SEPTIC IMPROVEMENT PERMIT / AUTHORIZATION TO CONSTRUCT / OPERATION PERMIT / EXISTING SYSTEM

RE: TS-II LP PPBPS Subsurface Effluent Disposal System
134 Honeydew Circle, Troutman, Iredell County, North Carolina

From: David DeCaron <ddecaron@pdapa.com>
Sent: Thursday, April 15, 2021 1:32 PM
To: Tara Larson Arbitter
Cc: Benjamin Botkins
Subject: Punch Items for Septic System on Honeydew
Attachments: Arbitter.pdf

AS BUILT SKETCH

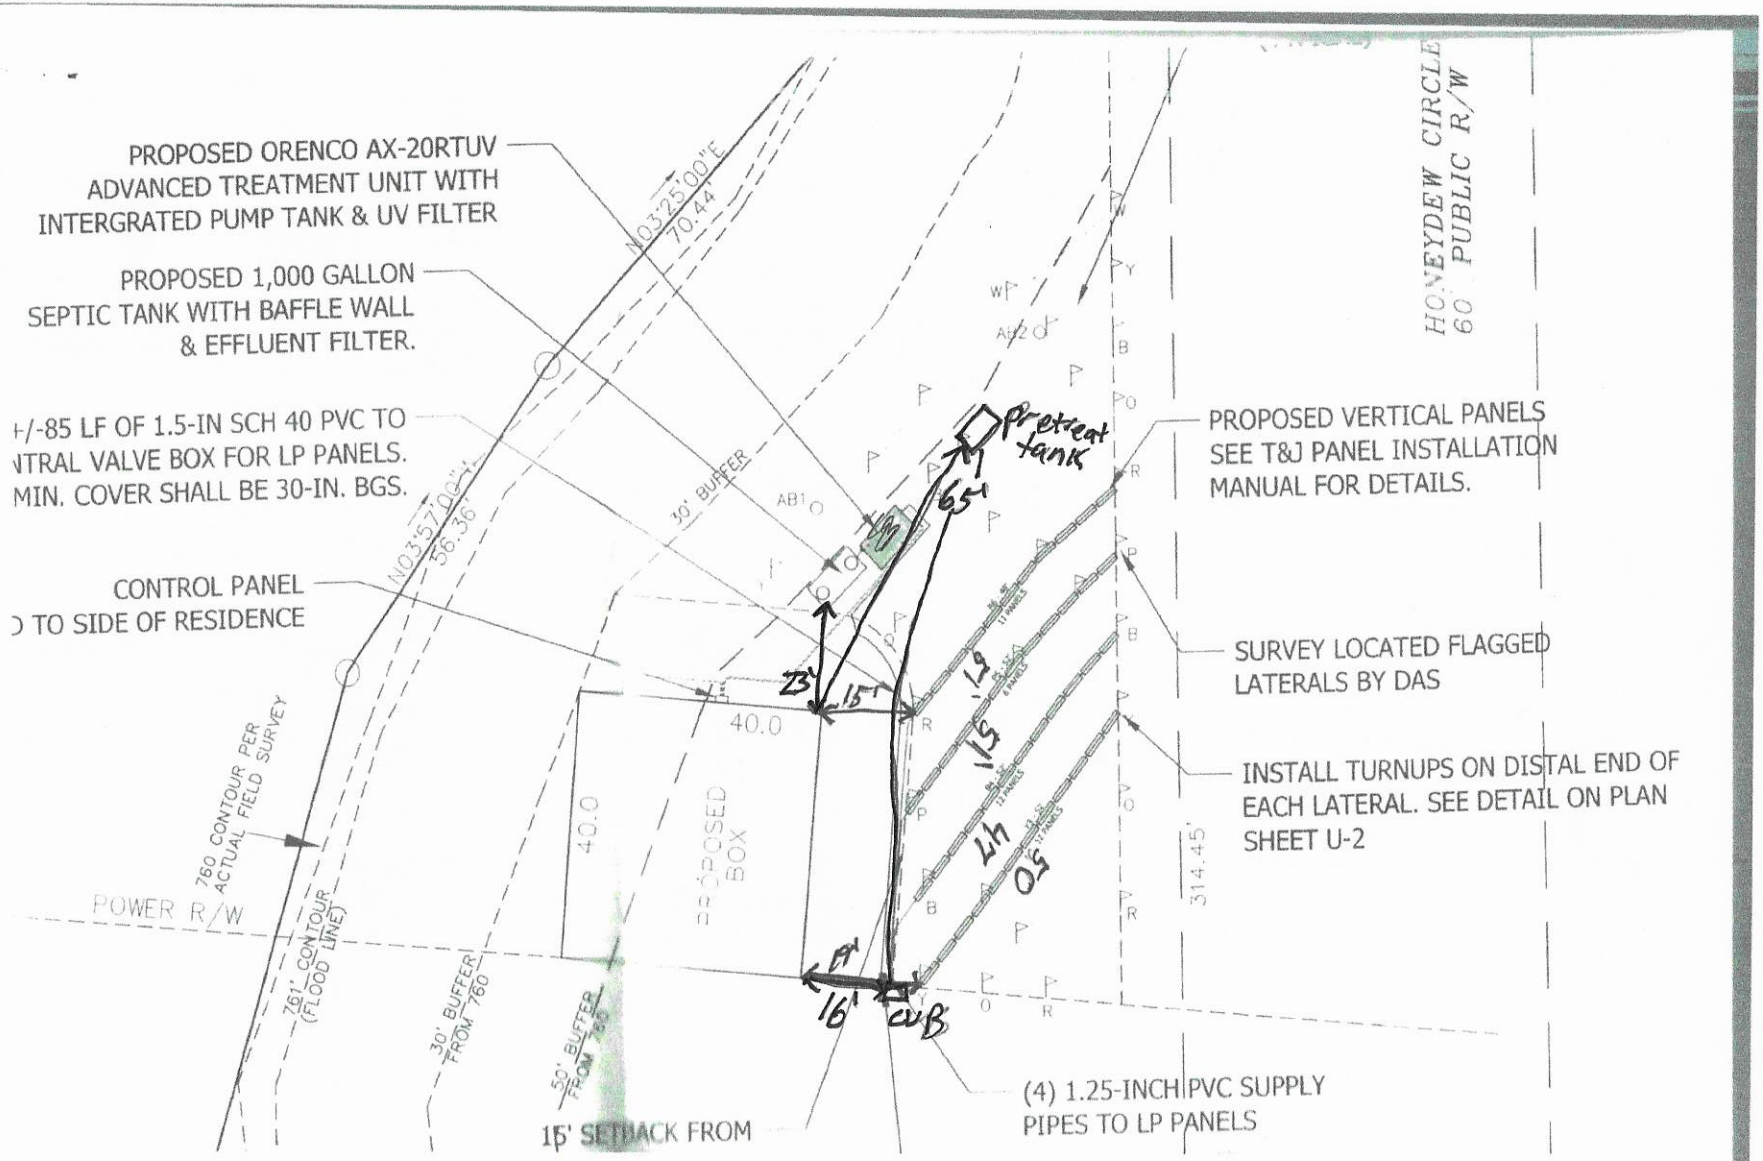
11/19/2020: Drainlines checked and were good all were 10' off property line and 15' off of house. As built on site sketch Not to scale

11/24/2020: Tanks, CVBand connections all checked and were good

↳ Landscape Final before OP
4-15-21* Pressure Head + Electrical checked
- Relocate waterline + need as built
- Remove Fandation Drain on Retaining wall close to Tank.

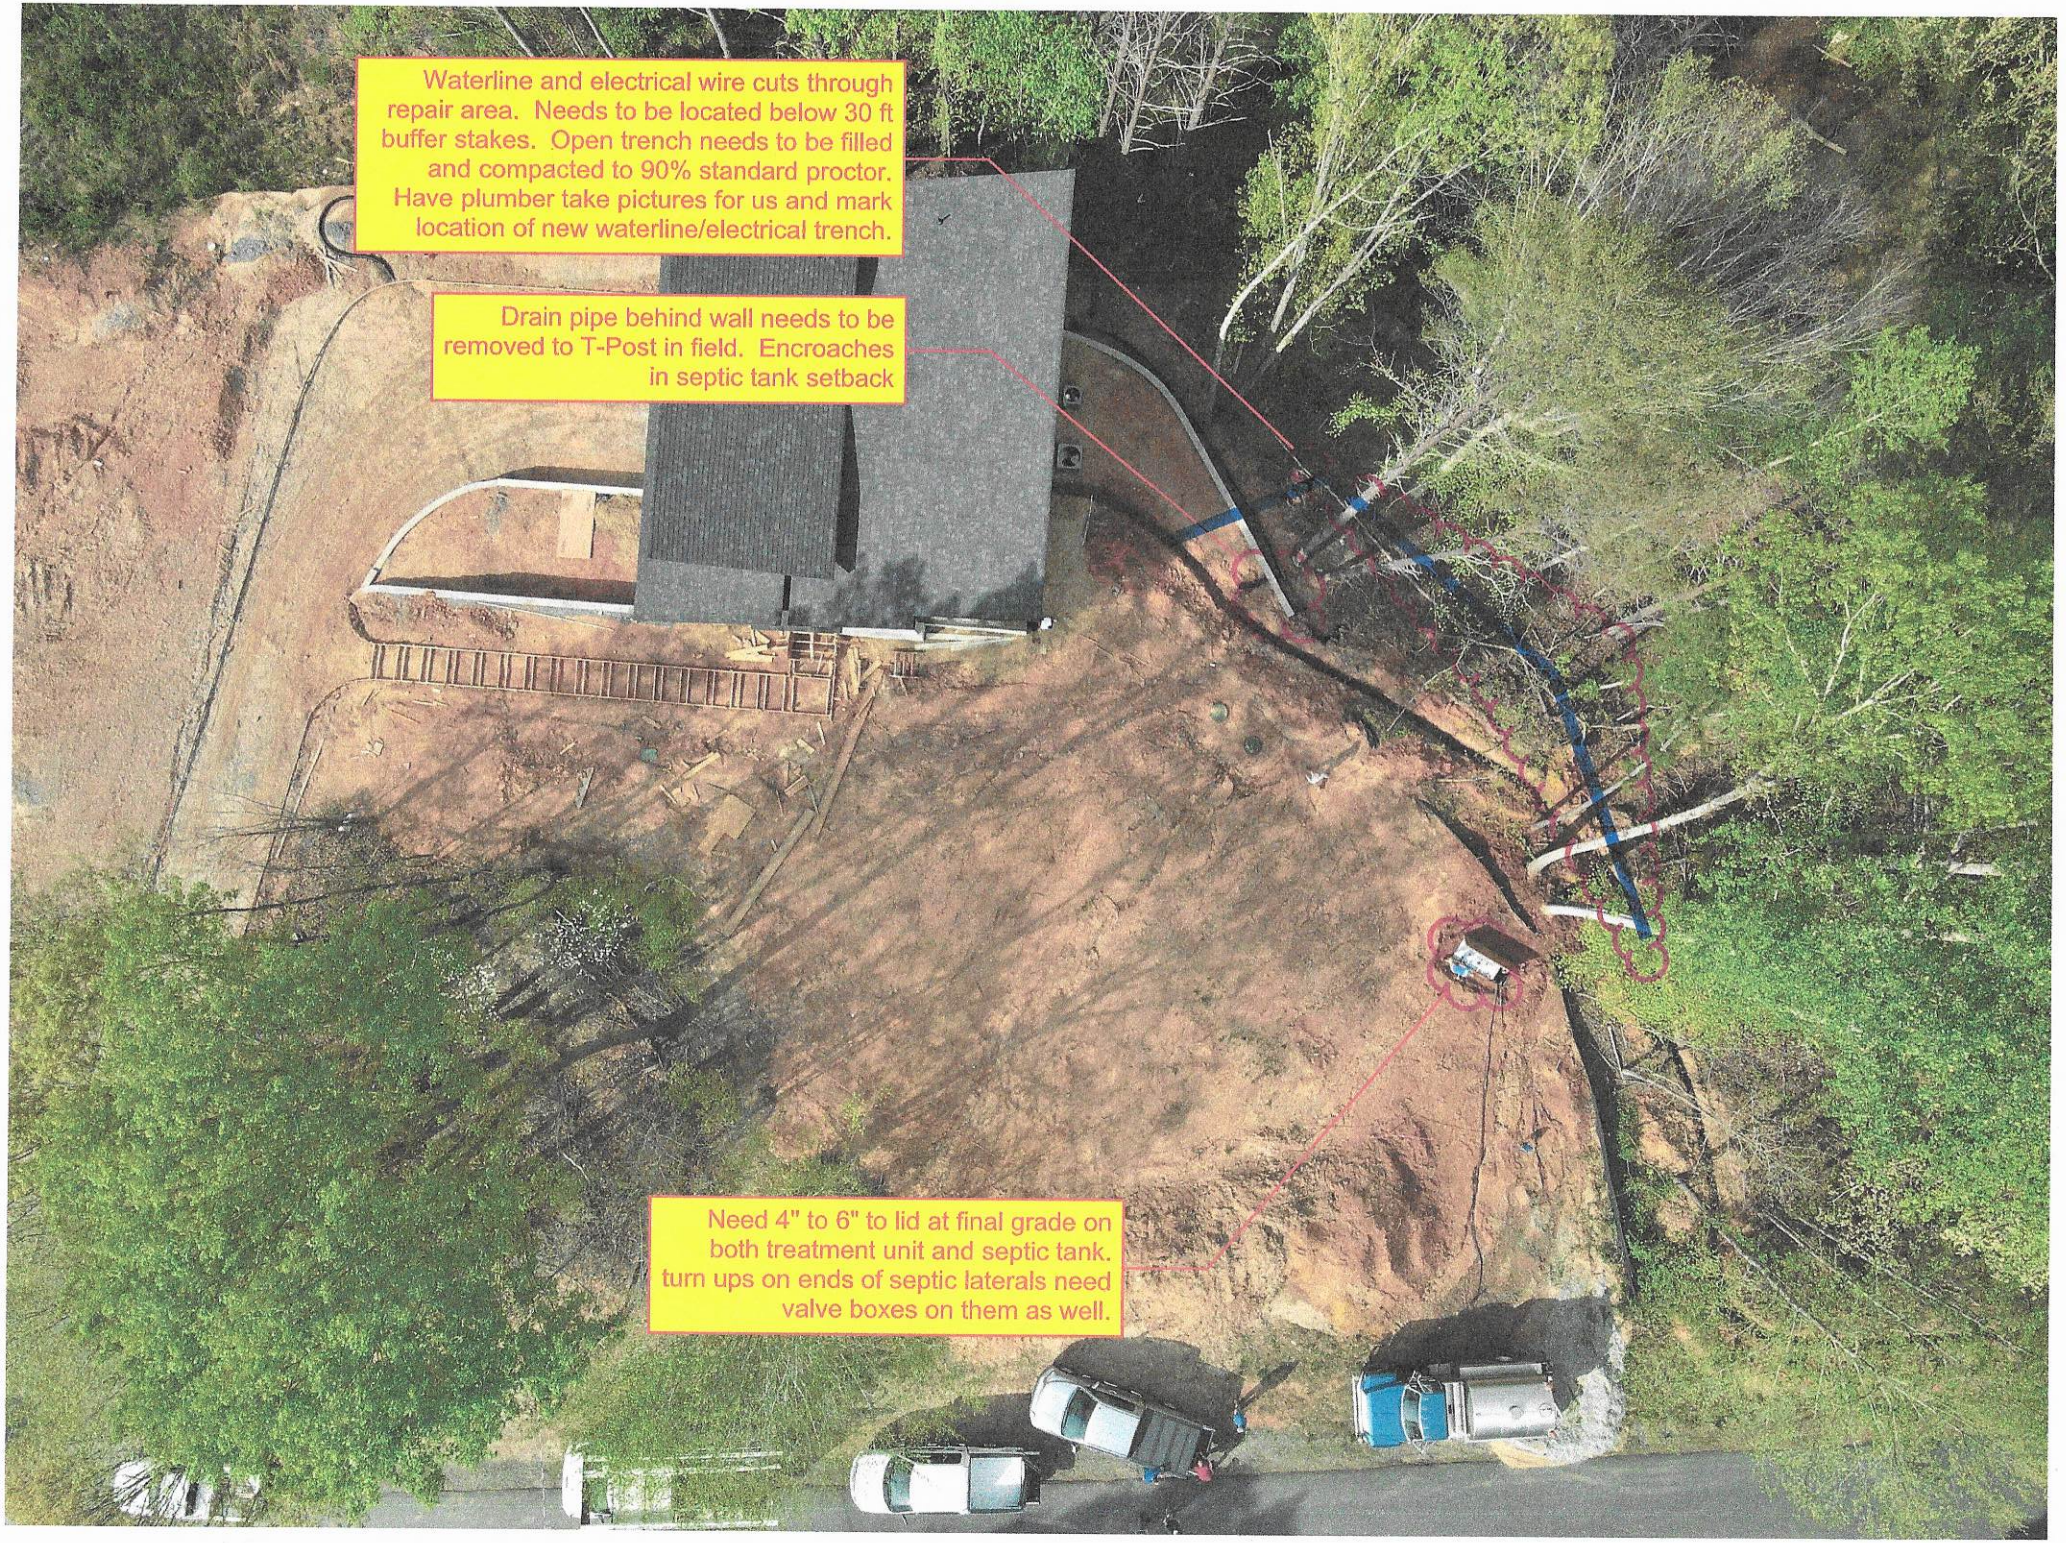
Waterline and electrical wire cuts through repair area. Needs to be located below 30 ft buffer stakes. Open trench needs to be filled and compacted to 90% standard proctor. Have plumber take pictures for us and mark location of new waterline/electrical trench.
Drain pipe behind wall needs to be removed to T-Post in field. Encroaches in septic tank setback
Need 4" to 6" to lid at final grade on both treatment unit and septic tank. turn ups on ends of septic laterals need valve boxes on them as well.
